PREVOST

SCI20-16

DATE :	October 2020	SECTION : 05 COOLING
SUBJECT :	FAN CLUTCH PLATE BOLTS RE-TORQUING

Figure 1 & 2 : If a bar code tag with a 10/6/2020 (and up) date is present on the box, the clutch is a late model production and does not need to be re-torqued (all models).

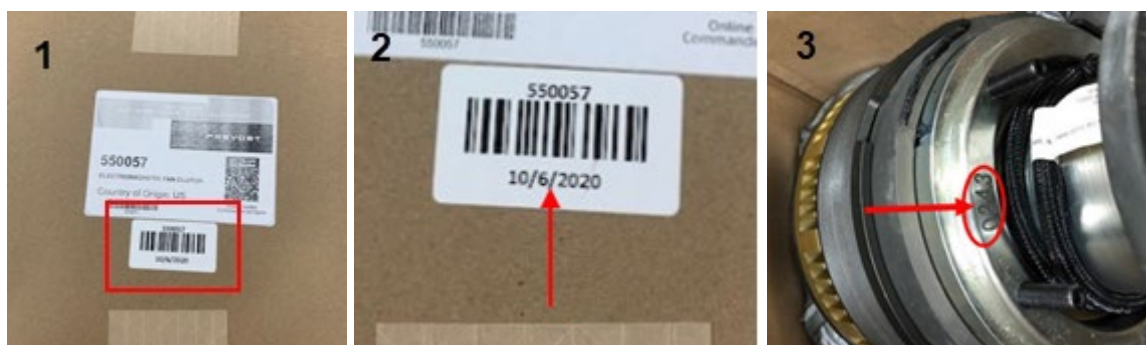
Figure 3 : Position of the clutch serial number (must be from 0448 to 0578)

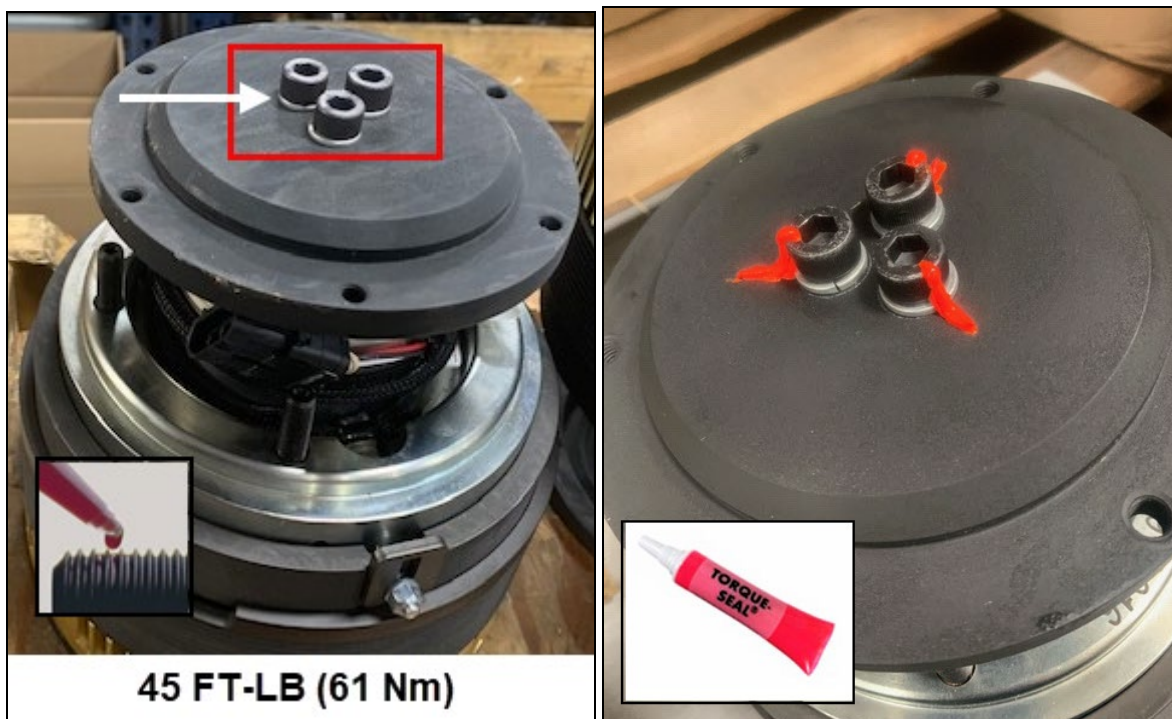
On the clutches affected by this bulletin, the three fan plate hex cap bolts (Allen type) may not have been torqued sufficiently and may become loose during operation. All units affected must have their bolts removed and torqued to proper spec using high strength (red) threads locker. This will ensure maximum service life and maximum performance of the clutches (see complete procedure below for details).

1. Unbolt the fan blade from the clutch (6 bolts). Lay the fan down in the fan shroud taking care not to damage the radiator core.
2. Remove and clean the 3 socket head fan plate bolts (M10x1.5 30 mm long).
3. Apply 272 high strength Loctite thread locker (or equivalent) to the 3 bolts.
4. Torque the 3 M10x1.5 bolts to **45 ft-lb (61 Nm)**.
5. Apply a stripe of tamper proof indicator paint (torque seal) to the bolt heads.
6. Reinstall the fan and torque the 6 bolts **32 ft-lb (43 Nm)**.

1. Remove 3 socket head fan plate bolts (M10x1.5 30 mm long).
2. Clean bolt threads and threads in the shaft with wire brush.
3. Apply 272 high strength Loctite thread locker (or equivalent) to the three bolts.
4. Torque the 3 M10x1.5 bolts to **45 ft-lb (61 NM)**.
5. Apply a stripe of tamper proof indicator paint (torque seal) to the bolt heads.
